## ZONING CHANGE REVIEW SHEET

**CASE:** C14-2016-0020 – Lantana IV

**ADDRESS:** 7717 Southwest Parkway

**Figure 1**

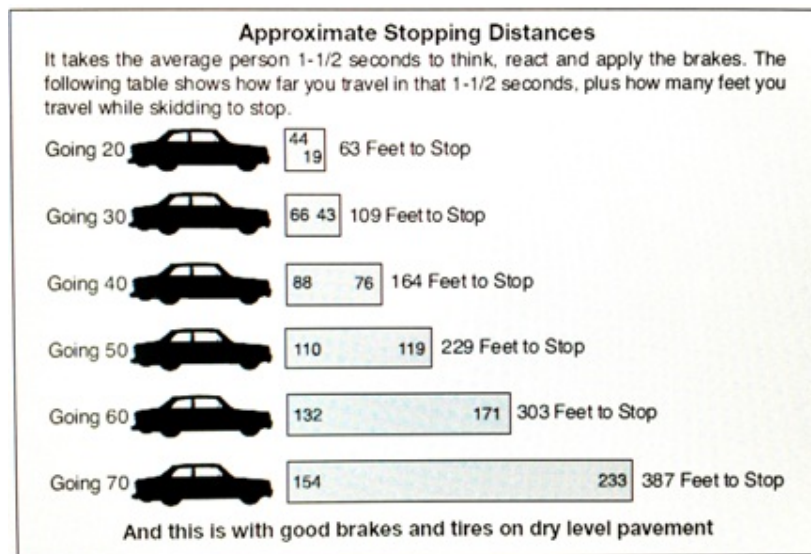
While all this data is important, the closing speed data, Table 5 and Figure 1, should be considered most carefully. Since there exists no lane for acceleration for vehicles making right or left turns onto Southwest Parkway where traffic is flowing at anywhere from 55 to 80 MPH, the turning vehicle has only seconds to get up to the traffic flow speed. In fact, if the flow is moving at 70 MPH an oncoming vehicle will cover the very short 528-foot sight distance in 7.5 seconds. Conservatively assuming it takes a turning driver 4 seconds to evaluate the situation in this uncontrolled median (i.e. look to the right to see oncoming traffic, look in front to see that no vehicle is going to go cross your path as you turn left, look toward your left to see if any vehicles in the oncoming left turn lane are initiating their turning movement, and then move one's foot from the brake to the gas), in the ensuing 7.5 seconds that it takes a vehicle to traverse the 528-foot sight distance range, the turning vehicle has but 3.5 seconds to accelerate to match the traffic flow and keep from either getting hit or becoming a roadway hazard. Virtually, no typical roadway vehicle accelerates from 0 to 70 MPH in 3.5 seconds. Table 5 shows the oncoming vehicle will have traveled 412 feet, leaving only 116 feet to identify the potential hazard and stop in case of an emergency, for example if the turning vehicle were to stall unexpectedly. The Texas Department of Public Safety prepared Figure 1 states that at 70 MPH the oncoming vehicle would need a minimum of 387 feet to stop. If the oncoming vehicle is distracted or boxed in its traffic lane to prevent taking avoidance action, a potentially deadly accident would be inevitable. This is the reality of the Southwest Parkway at Terravista intersection right now. This is certainly not the situation for the William Cannon at Rialto intersection.

My point once again is while I agree with you that all four of the intersections that ATD has identified as needing traffic lights, the Southwest Parkway at Terravista is the one that poses the greatest danger to life and limb due to the fact that it has the highest closing speeds and the shortest sight distance. I realize you operate with severe budget constraints; so as you prioritize where the available funds will be spent, please consider the danger that each of the four intersections pose to the general public. While they may appear to be equally important from a planning perspective, they are not from a practical perspective. Please consider the number of high speed collisions that have been recorded over the past several years. Bear in mind that Lantana Tract IV is proposing to have as one of its first users a Montessori school for children. There will be constant traffic in and out of the very place where today's collision occurred. Over the coming months there will be considerably more traffic there due to current development, and there will be a steady stream of vehicles, including heavy construction, moving at speeds of 70 to 80 miles per hour. Some things are just not about money.
